ICHD - ENVIRONMENTAL HEALTH DIVISION

PERMIT # AP 318261

SEPTIC: IMPROVEMENT PERMIT / AUTHORIZATION TO CONSTRUCT / OPERATION PERMIT / EXISTING SYSTEM

SITE ADDRESS: 114 Dunn Ross Ct Mooresville, NC 28117 | PHONE: 7043600376 | ALT. PHONE

INITIAL SITE SKETCH

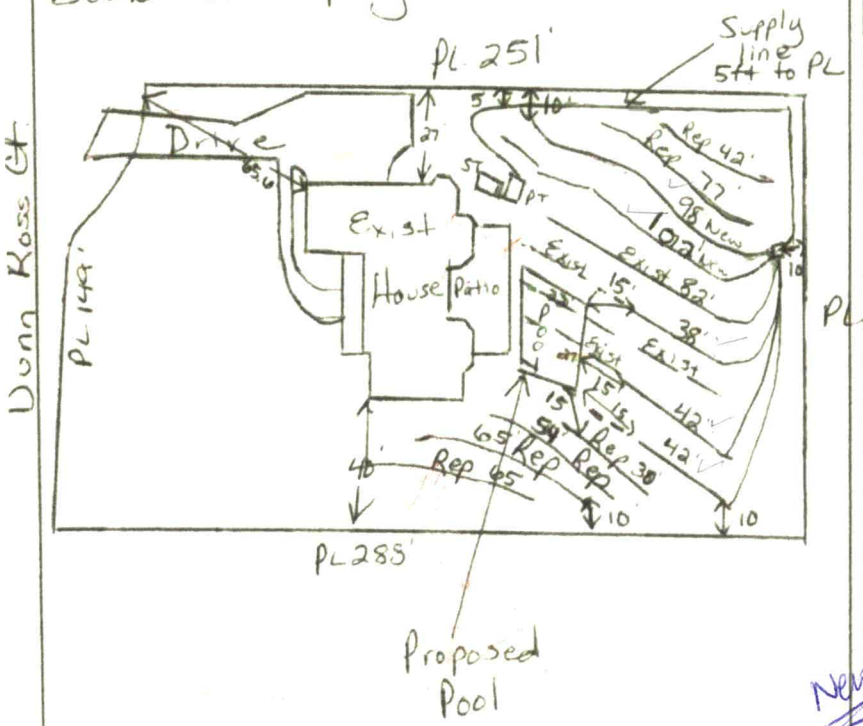
Comments / Conditions: Abandon any part of Existing Septic System that's < 15ft from pool cut.
Relocation of Septic System to accomodate pool.

Pressure Manifold: Use 3/4" sch 40 tap for 98ft & 102' lines
Use 3/4" sch 80 tap for 82ft line
Use ~~1/2" sch~~ 80 tap for 38ft & 42ft lines — Combined

10/1/21 Checked PT & line abandonment of lines within 15ft

10-4-2021 CONNECTION BETWEEN BUN LAST 2 LINES CHECKED

10/5/21 Checked 102' line

10/6/21 Checked 98' line, manifold

Supply line leaking 10/13

Manifold: 3/4" SCH 40 tap – 98' & 102' > 200' together

1½" SCH 80 tap – 84'

1" SCH 40 tap feeding 42', 42' & 38' > 122' together

New → Flow: 25.09 gpm Drawdown - 8.7"
Dose: 183.82 Run Time - 17.33min
